National Electrical Safety Code
Interpretations
1981—1984 inclusive

**ANSI/IEEE C2
Interpretations 1981-1984**

This edition includes official interpretations of the National Electrical Safety Code as made by the Interpretations Subcommittee of the National Electrical Safety Code Committee, ANSI C2.

Fig IR 295

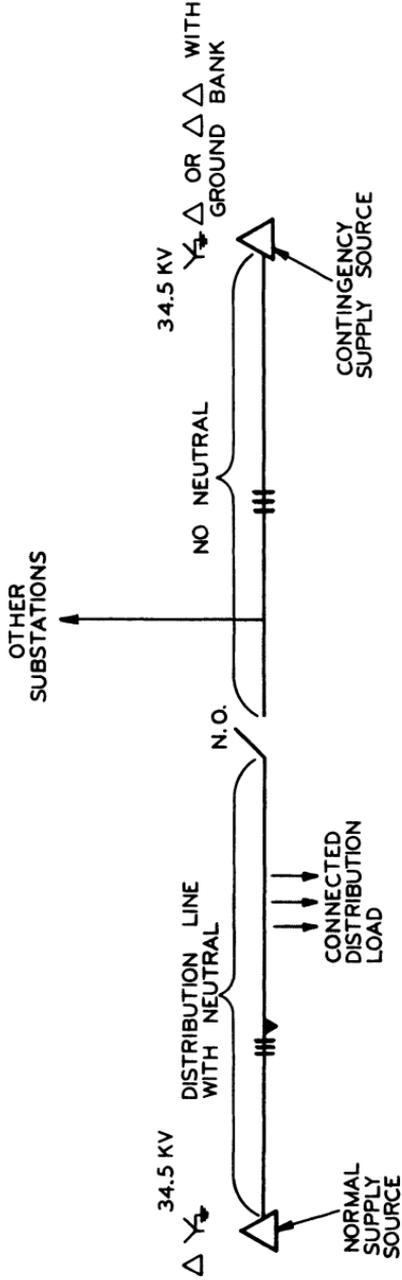
In some cases, where a back-up or contingency source exists and is occasionally used, the neutral conductor, while completely continuous in the area where distribution equipment is connected, may not be continuous to the contingency source, that is, there may be a section of circuit between the load area and the contingency source that lacks the neutral conductor. However, the overall system grounding in the load area as measured with the contingency source in operation is still such as to limit voltages on unfaulted phases to acceptable values, and adequate ground fault current is available for proper protective relaying. The enclosed drawing illustrates a potential situation.

We do not believe that the lack of the continuous neutral conductor as described above violates any requirements of the National Electrical Safety Code (NESC), particularly Section 9, Paragraph 92 and Section 21, Paragraph 215. May we have your concurrence on our interpretation.

Fig IR 340-1

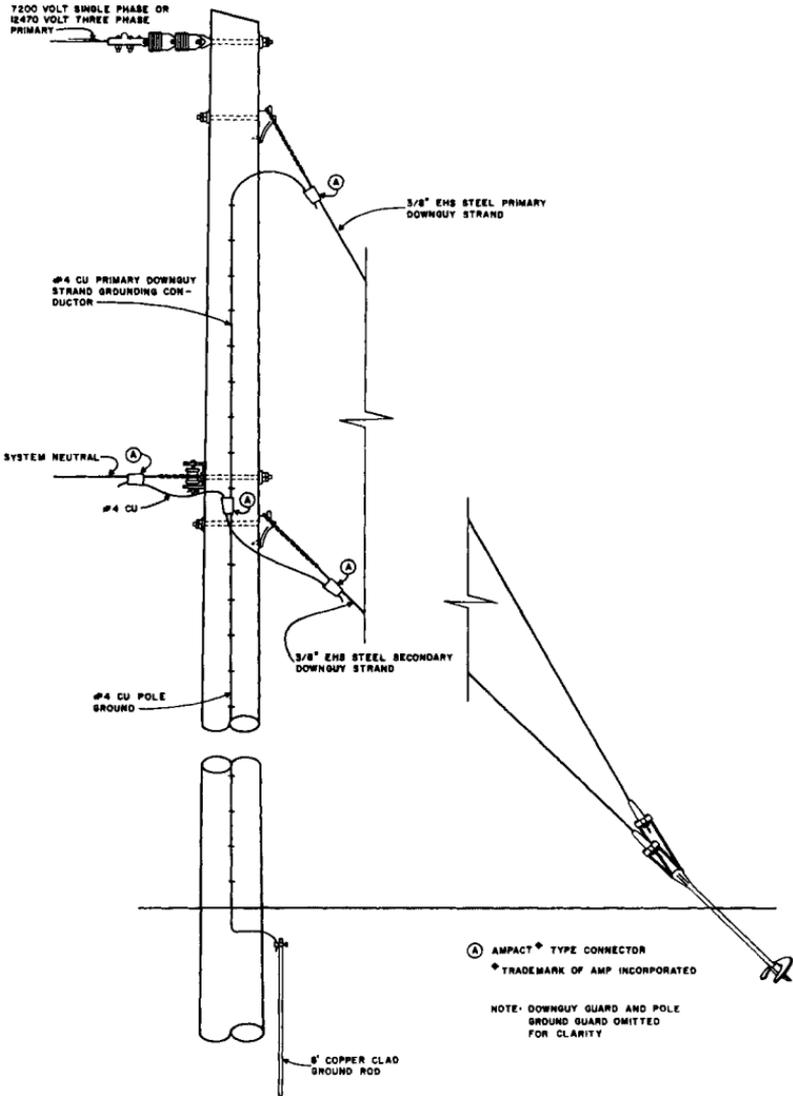
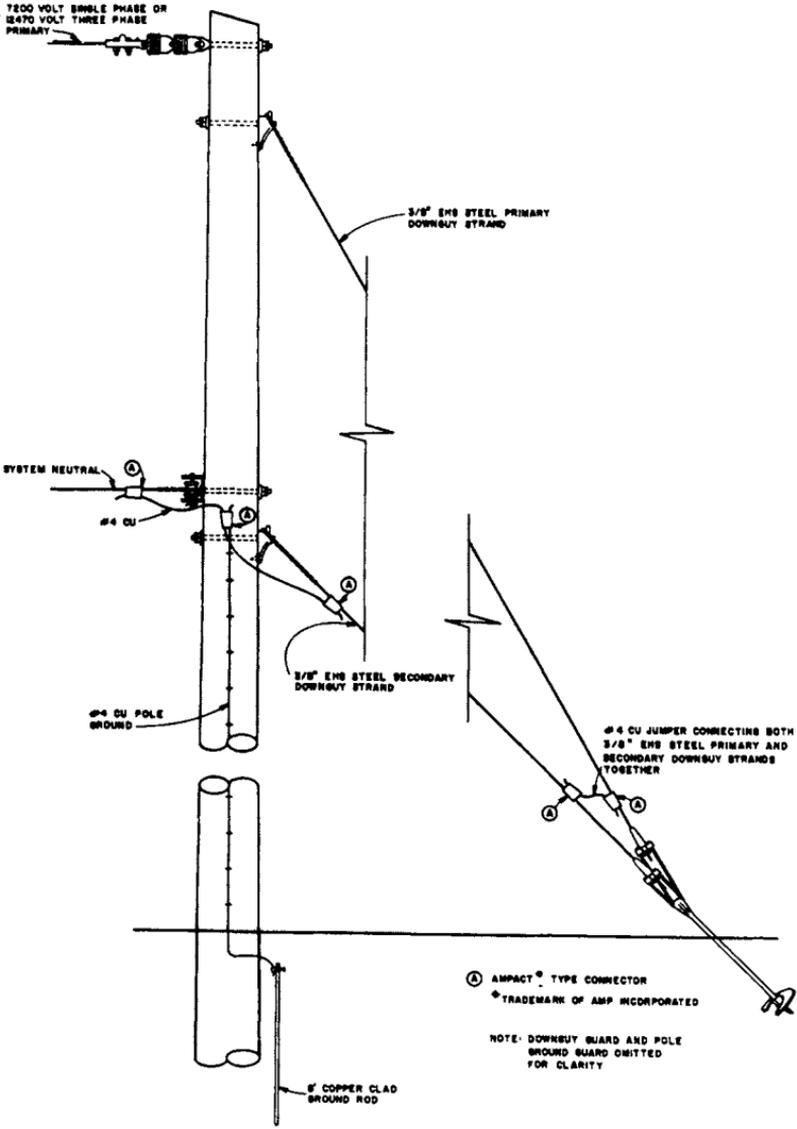
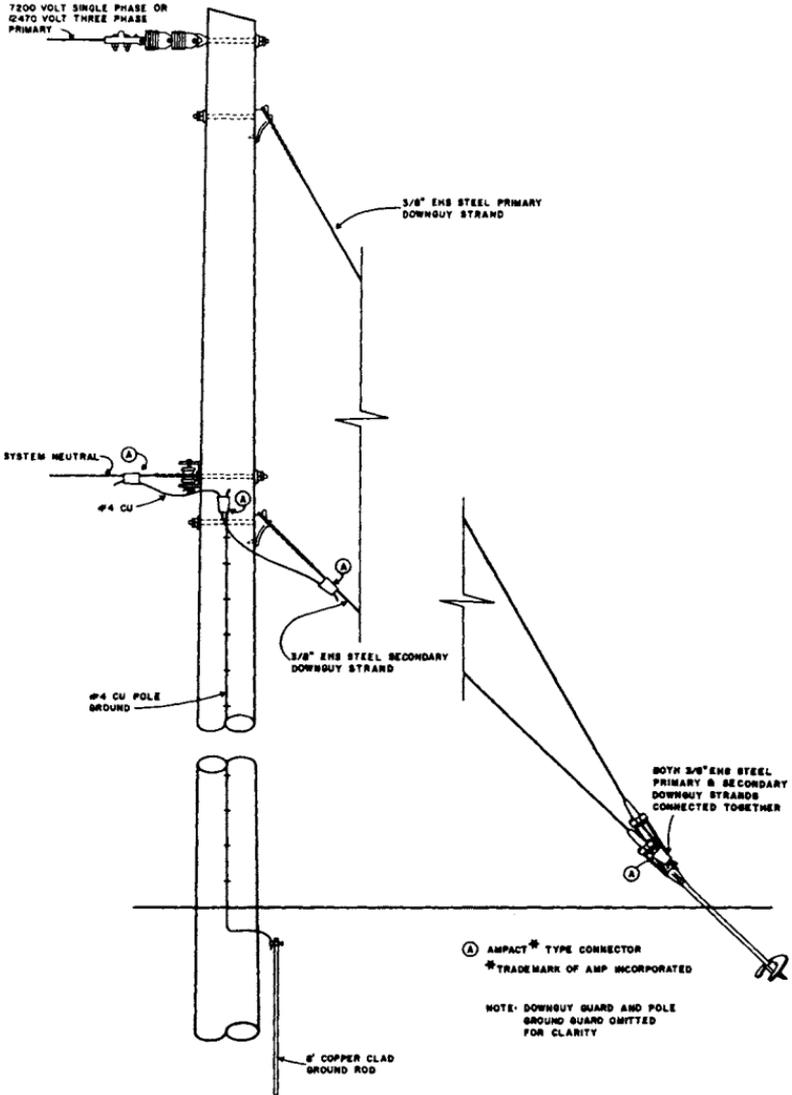
Our request is for interpretations of these proposed configurations shown in Figs IR 340-2,3 with respect to the following National Electrical Safety Code (NESC) Rules:

- (1) NESC Rule 215C2 requires that downguy strands without insulators, attached to supporting structures carrying conductors of more than 300 volts shall be effectively grounded. Will the proposed configurations satisfy this requirement?
- (2) Will the point of connection of the grounding conductor of the proposed configuration shown in Figs IR 340-2,3, satisfy the requirements of NESC Rule 92C2?
- (3) By NESC definition the secondary downguy strands, shown in Figs IR 340-2,3, will be the grounding conductor for the primary downguy strands. Will the requirements of NESC Rule 93D1 or 93D3 negate the proposed configurations shown in Figs IR 340-2,3, as an alternative for grounding the primary downguy strand?

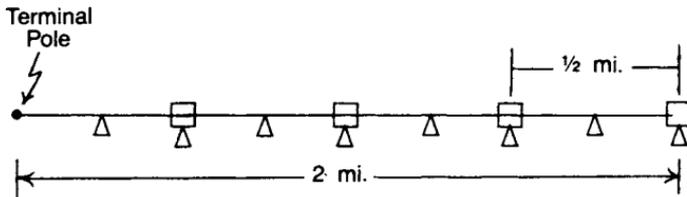
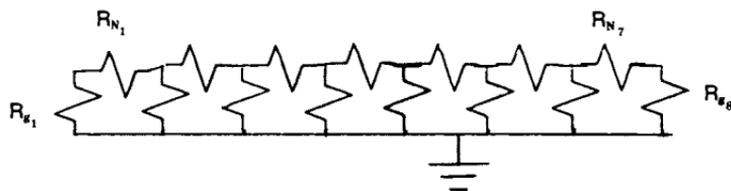
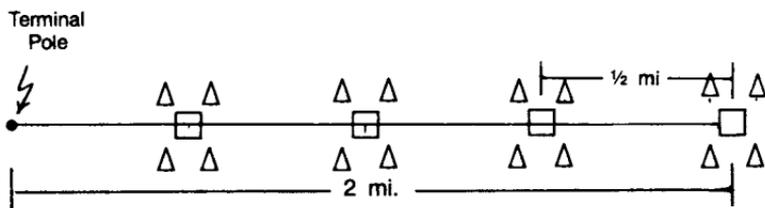
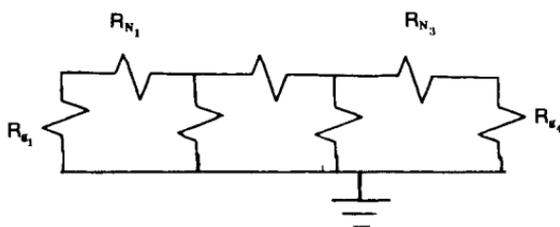
In our case, we plan to install two miles of insulated jacketed cable. Sectionalizing enclosures are to be placed one-half mile apart and a 3/4 in × 8 ft ground rod installed. Also, halfway between each enclosure another ground rod needs to be added by stripping back the jacket and making a suitable connection to the concentric neutral. This area needs to be sealed again to prevent moisture from entering. (Please see Fig IR 341-1.)

If this two-mi piece of line is electrically isolated at each end, a neutral-to-earth resistance can be calculated based on the 2000 ohm-centimeter soil in the area. (Please see Fig IR 341-2.) This is the base line case.

Fig. IR 322

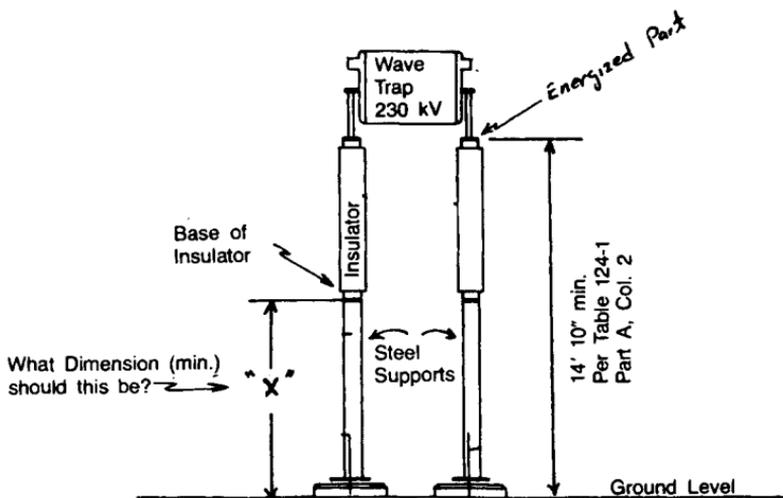
Does rule 124A in any way state that a minimum distance must be maintained between the bottom of porcelain and ground level (dimension "X" in sketch)? The last sentence of Footnote 1 of Table 124-1 is in essence saying that a minimum distance of 8 ft 6 in must be maintained between bottom of porcelain and ground level on surge protective devices, but no mention is made of other devices such as wave traps, bus support insulators, etcetera.

Our review of past interpretations by this subcommittee on this subject indicates that IR 86 of May 1, 1957, asked specifically 'Is the entire porcelain portion of a lightning arrester considered a "live part" in the measurement of distance in the Rule and in Table 2?' (underline added). The Interpretation provided by the subcommittee at that time was based on the Fifth Edition of the National Electrical Safety Code (NESC) and was: 'The point of measurement is from the actual "live part" rather than from some part of the porcelain body of the arrester.' While this interpretation is correct for that edition of the code and also applies to later editions, we believe that it is not a complete explanation of current code requirements and offer further comment herein.

Fig. IR 355

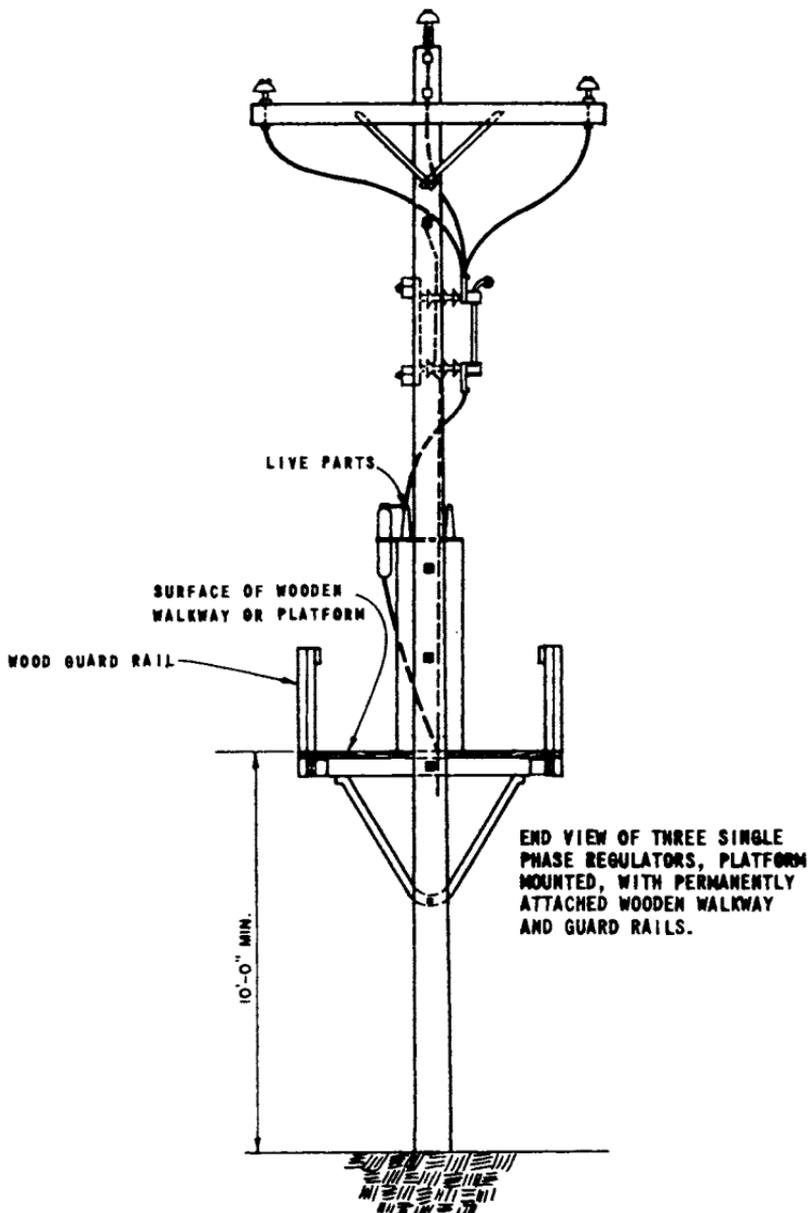
If the installation is not in the category of Part 1 of the National Electrical Safety Code (NESC), then does it fall in the category covered by Rule 286D, "Equipment on Supporting Structures" and require only the clearances to "live parts" required by rule 422B?

Fig. IR 319-1

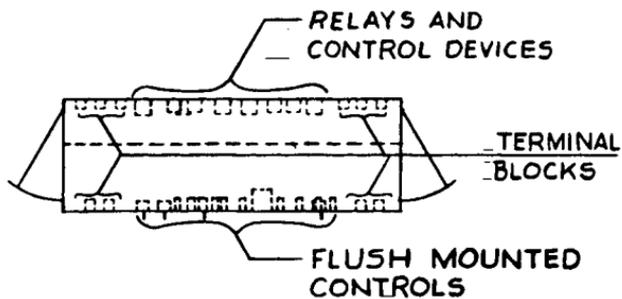
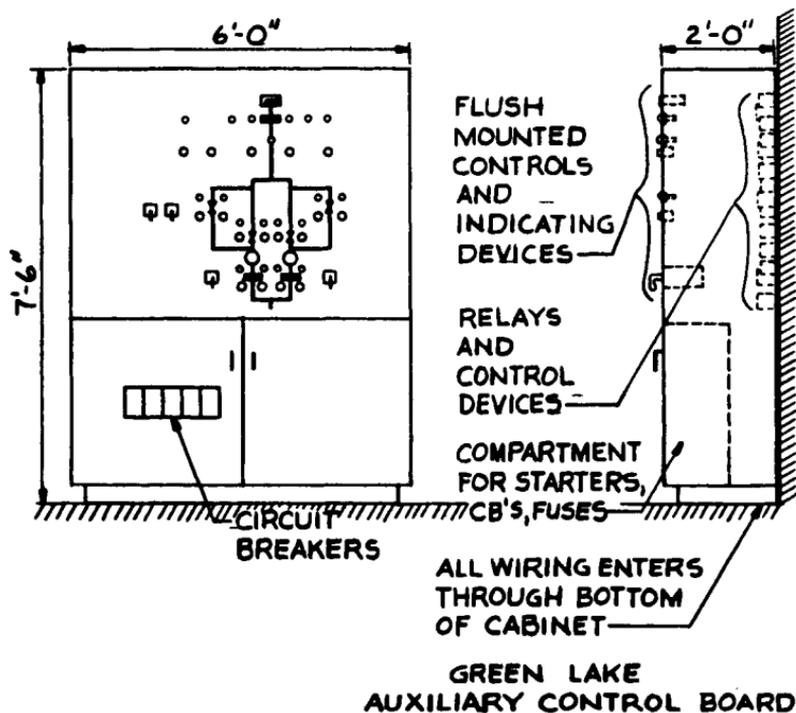
We request an interpretation of Article 125 as to whether the minimum clearances listed in Table 125-1 must be maintained in front of energized components inside of non-walk-in type control boards such as described above, in order to comply with Article 125.

Fig IR 349

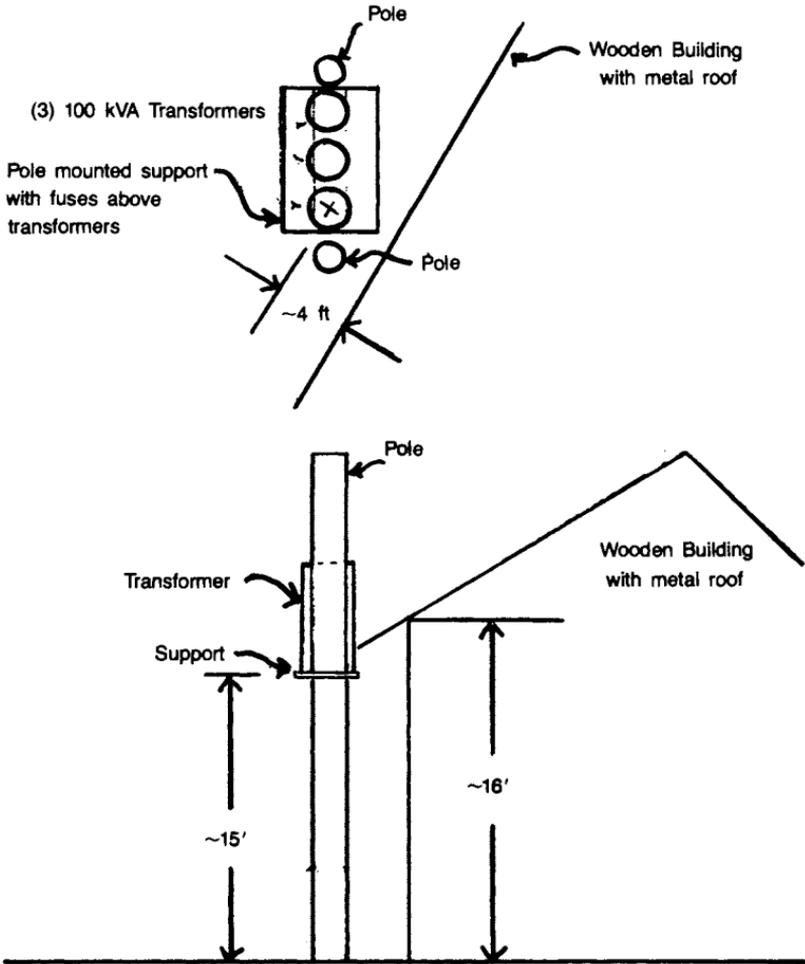
The particular question involves the National Electrical Safety Code (NESC), section 152A2. The primary question in my inquiry is since oil filled transformers shall be located and protected to minimize fire hazards, was the space consideration in this installation sufficient? As can be seen in one of the sketches, the approximate center line of the nearest transformer was approximately 4 ft from the building. Again, the basic question is, was space separations sufficient in this particular case.

Fig IR 345

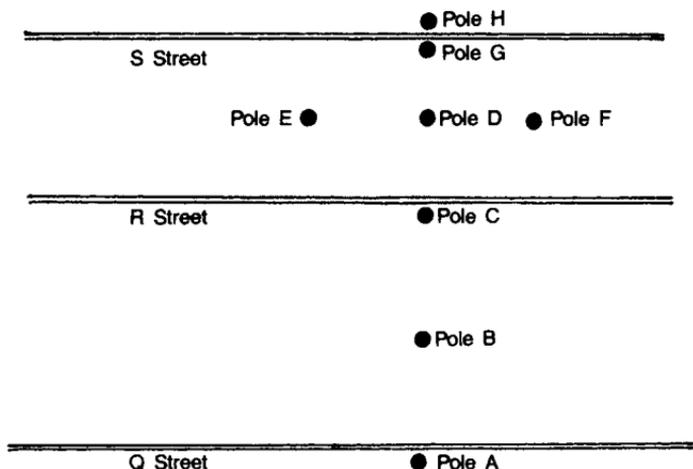
The power company states that the installation meets all Code requirements. Prior to 1981 the span between poles D and G would have been in clear violation of Rule 211. Does the 1981 Edition of the Code permit energized wires, serving no purpose other than mechanical support for a pole, to run within three inches of the trunk of a readily climbable tree? If not, what rule prohibits such an installation?

Fig IR 324

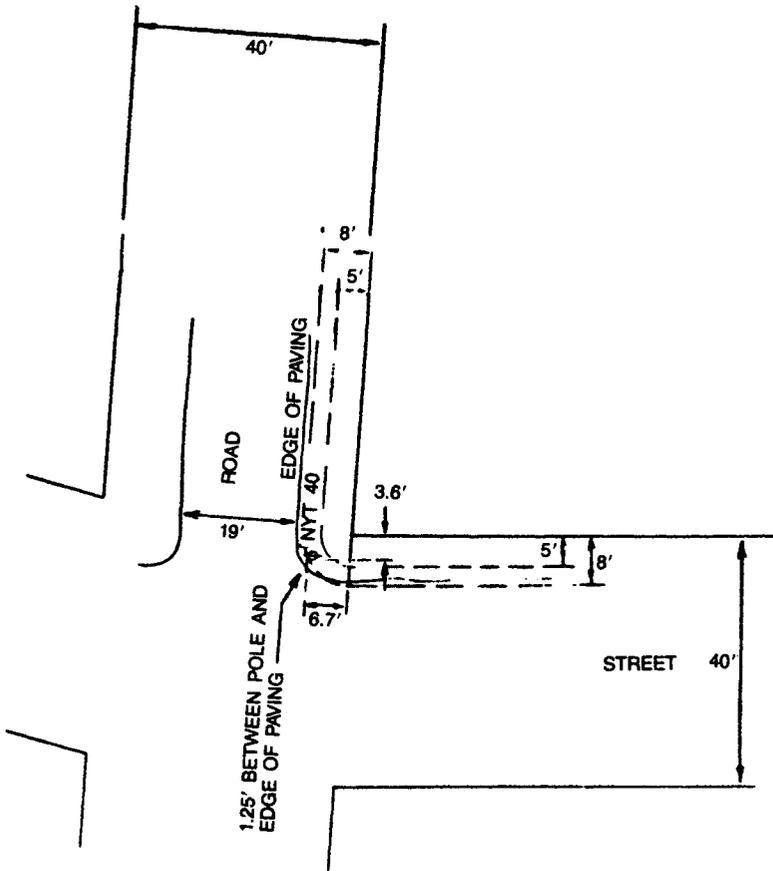
... I am taking the liberty of enclosing photostatic copy of a road survey covering a road intersection which involves a certain supporting structure depicted as NYT46. . . . You will note that [on both the street and the road] there is a 40 ft right of way and my question to you is whether under Rule 231B2, the Code recommends that the involved supporting structure be placed at or near the right of way line, which translated on this chart means at the outer limit of the 40 ft right of way, provided of course there was no obstruction to prevent same?

Your September 1 letter with location sketch does not provide sufficient information for a definitive answer as to an acceptable location for the supporting structure. Note particularly in the National Electrical Safety Code (NESC) 1981 Edition, Rule 231B2: "Where there are no curbs, supporting structures should be at or as near as practical to the . . . right of way line." (Underlines are ours.) Note also Rule 015.

Fig IR 337

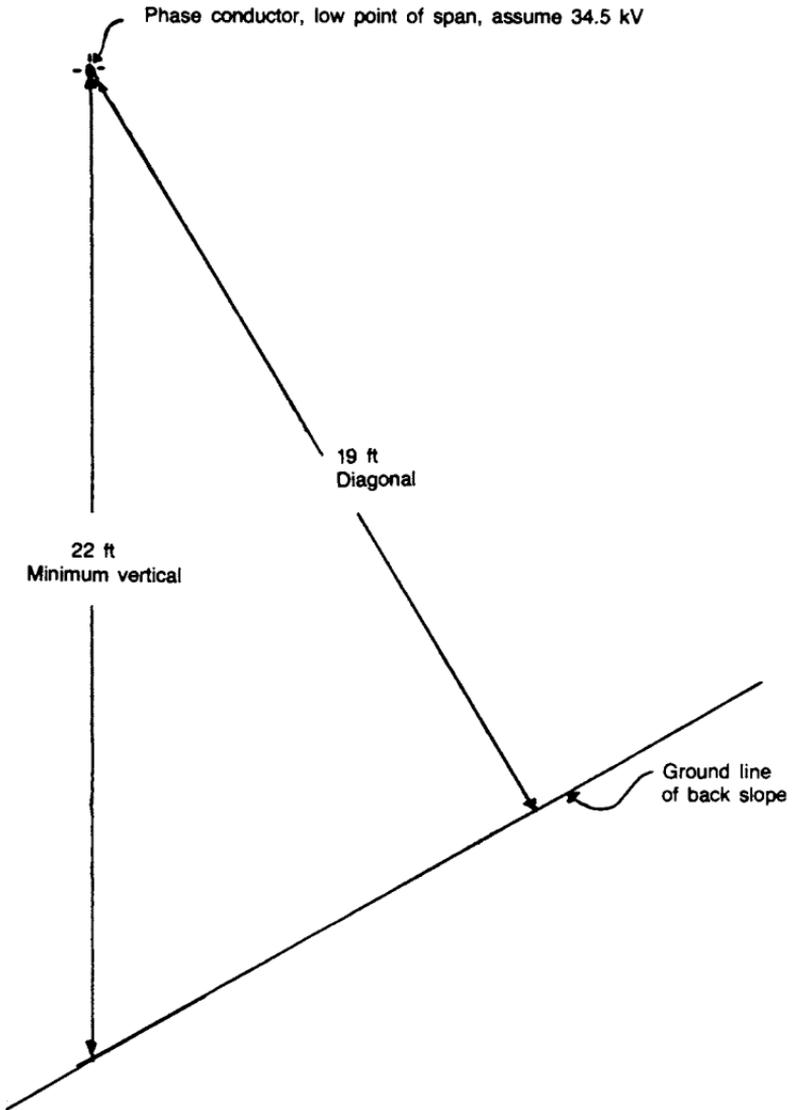
In Section 23, Rule 232 of the 1981 National Electrical Safety Code (NESC), I can find no information on diagonal clearances from an overhead conductor to ground. When building electrical lines I often encounter areas where severe backslopes parallel to the centerline of the electrical line, and the distance from a given point on the backslope to the phase conductor will be less than the vertical distance from ground to the phase wire (see Fig IR 337). My question is, since the Code Book makes reference to only vertical clearance from ground, should the diagonal distance be considered as the minimum in these cases?

- (1) Could you explain why in Section 23, Rule 230E1 and 2 neutrals associated with circuits above 22 kV are required to have the same clearance as the phase conductors, and
- (2) Section 23, Rule 232, Table 232-1 No. 10, why was 14 ft established as the minimum for neutral conductors in this case?

The remainder of the questions, (b) and (c), are not requests for interpretation and no official response will be given.

Fig IR 361-1

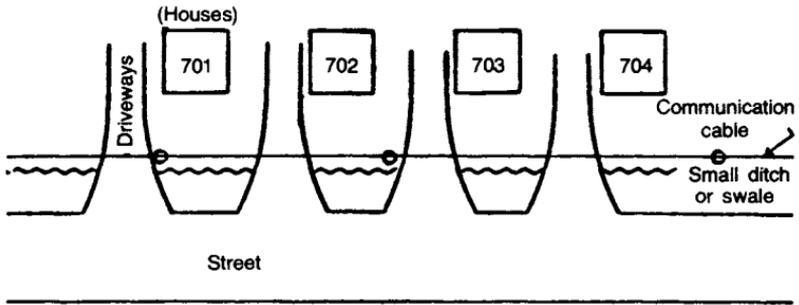
What should the minimum height of the cable be?

Fig IR 361-2

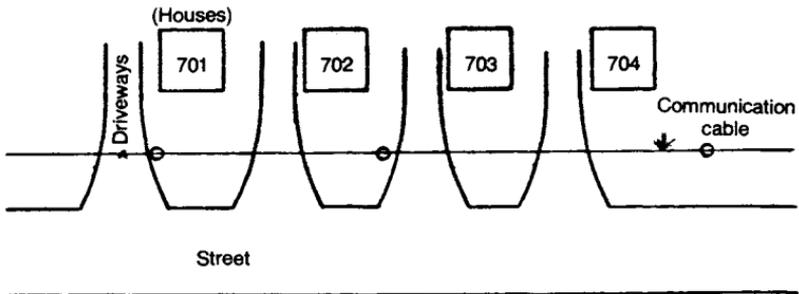
What should the minimum height of the cable be?
